Access Compliance Report

Public Rights-of-Way

(Pedestrian Signals)

Intersection ID: N/A	Main Street:	Cross Street: N/A	Location: N/A
ADA ID: CDEC8CB2D91	Signal Type: Two Push Buttons-APS	Overall Compliance: No	Severity Score: BTN 1:N/A BTN 2: N/A No BTN: N/A
Codes/Mitigation Info/Possible Solution		Field Measurements/Component Compliance

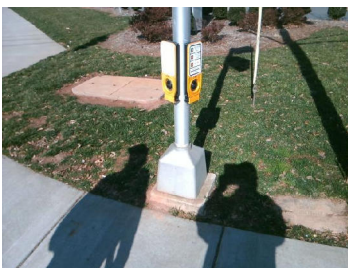
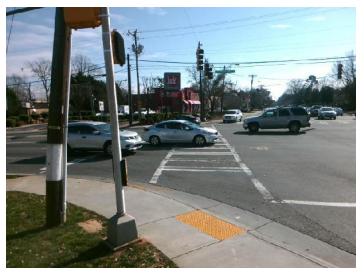
Compliance	Description	Data	Compliance	Description	Data
	Button Count	Button2	N/A	Distant to Additional Button (in)	N/A
	Additional Button Present?	No		Additional Button ID	N/A
N/A	Signal Buttons Required?	N/A	N/A	Additional Ped Posts Required	N/A
	How Many Ped Street Xings?	2		Located In An Island/Median?	No
N/A	B 1 Sign Present?	Yes	N/A	B 2 Sign Present?	Yes
Yes	B 1 Sign Purpose?	Yes	No	B 2 Sign Purpose?	No
Yes	B 1 Sign Lettering & Contrast?	Yes	No	B 2 Sign Lettering & Contrast?	No
Yes	B 1 Parallel To XWalk?	Yes	Yes	B 2 Parallel To XWalk?	Yes
Yes	B 1 PAR to Button?	Yes	Yes	B 2 PAR to Button?	Yes
Yes	B 1 PAR to XWalk?	Yes	Yes	B 2 PAR to XWalk?	Yes
Yes	B 1 Clear Floor Space?	Yes	Yes	B 2 Clear Floor Space?	Yes
N/A	B 1 FWD Approach?	Yes	N/A	B 2 FWD Approach?	Yes
N/A	B 1 FWD Approach Constrained?	No	N/A	B 2 FWD Approach Constrained?	No
No	B 1 FWD Approach Reach (in)	24.0	No	B 2 FWD Approach Reach (in)	11.0

N/A	B 1 FWD Approach Width (in)	N/A	N/A	B 2 FWD Approach Width (in)	N/A
N/A	B 1 FWD Approach Obstruction?	Yes	N/A	B 2 FWD Approach Obstruction?	Yes
N/A	B 1 FWD Approach Obstruction Dist (in)	16.0	N/A	B 2 FWD Approach ObstructionDist (in)	4.0
N/A	B 1 PARA Approach?	Yes	N/A	B 2 PARA Approach?	Yes
N/A	B 1 PARA Approach Constrained?	No	N/A	B 2 PARA Approach Constrained?	No
Yes	B 1 PARA Approach Reach (in)	9.0	Yes	B 2 PARA Approach Reach (in)	7.0
N/A	B 1 PARA Approach Width (in)	N/A	N/A	B 2 PARA Approach Width (in)	N/A
N/A	B 1 PARA Approach Obstruction?	Yes	N/A	B 2 PARA Approach Obstruction?	Yes
N/A	B 1 PARA Approach Obstruction Dist (in)	3.0	N/A	B 2 PARA Approach ObstructionDist (in)	3.0
Yes	B 1 Clear Floor Space Slope (%)	1.4	Yes	B 2 Clear Floor Space Slope (%)	1.3
No	B 1 Clear Floor Space XSlope (%)	7.7	No	B 2 Clear Floor Space XSlope (%)	7.7
N/A	B 1 PAR Slope (%)	0.7	N/A	B 2 PAR Slope (%)	0.7
Yes	B 1 Height (in)	39.0	Yes	B 2 Height (in)	39.0

Yes	B 1 Clear Xing Direction?	ClearlyMarked	Yes	B 2 Clear Xing Direction?	ClearlyMarked
	B 1 Crossing Direction	To SW		B 2 Crossing Direction	To SE
Yes	B 1 DistanceTo XWalk (in)	0.0	Yes	B 2 DistanceTo XWalk (in)	0.0
No	B 1 DistanceTo Curb (in)	81.0	No	B 2 DistanceTo Curb (in)	80.0
Yes	B 1 Diameter (in)	2.0	Yes	B 2 Diameter (in)	2.0

Possible Solutions: Replace Signal Push Button With APS Button on New Post.
Remove & Relocate Sign. Remove & Replace Sign.

PROW/ADA: TMUTCD 4e.08, R404.2, R406.2, , R209.1, R410.6
